Additional support of the elevator push rod.

Urgency: Immediately.

The modification 7 must be made at all gliders, except the after 6 modified ones.

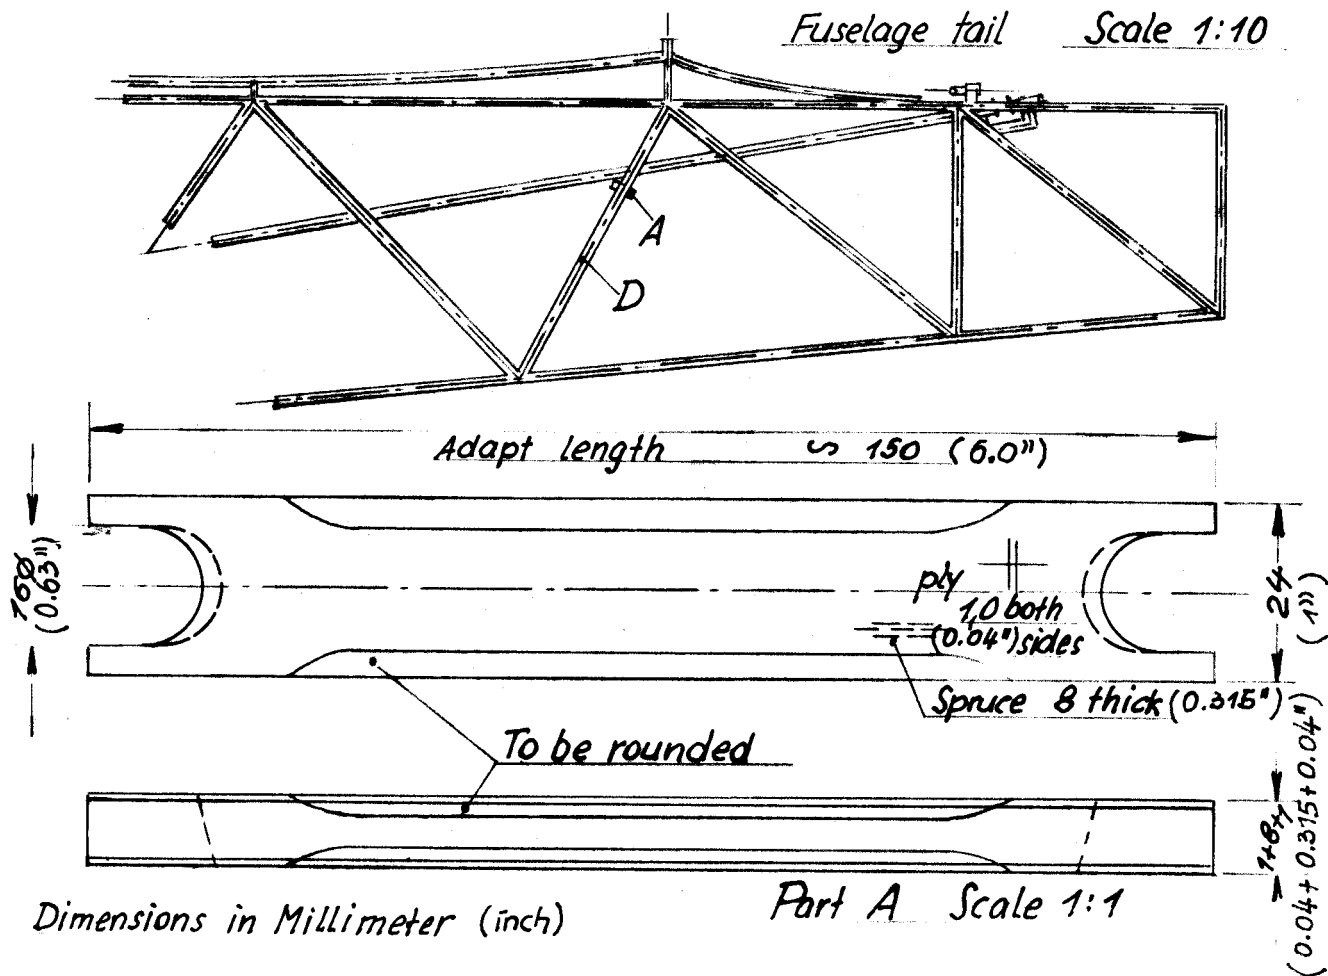
It is supposed that by elasticity of the push rod the ball bearing of the elevator lever has sprung out.

The modification must be inspected by an aircraft inspector and signed.

Part A to be put into the V-steel tubes D so that the elevator push rod in its lowest position is going just free (about 1 mm distance). Part A must sit tight in the tubes without damaging or bending the tubes. Part A is then fixed with the tubes by linon tape and adhesive dope.

The works can be done from the opening for the tailplane. At gliders having a flettner trim there may be some sliding of the control wire. This point should be well rounded.
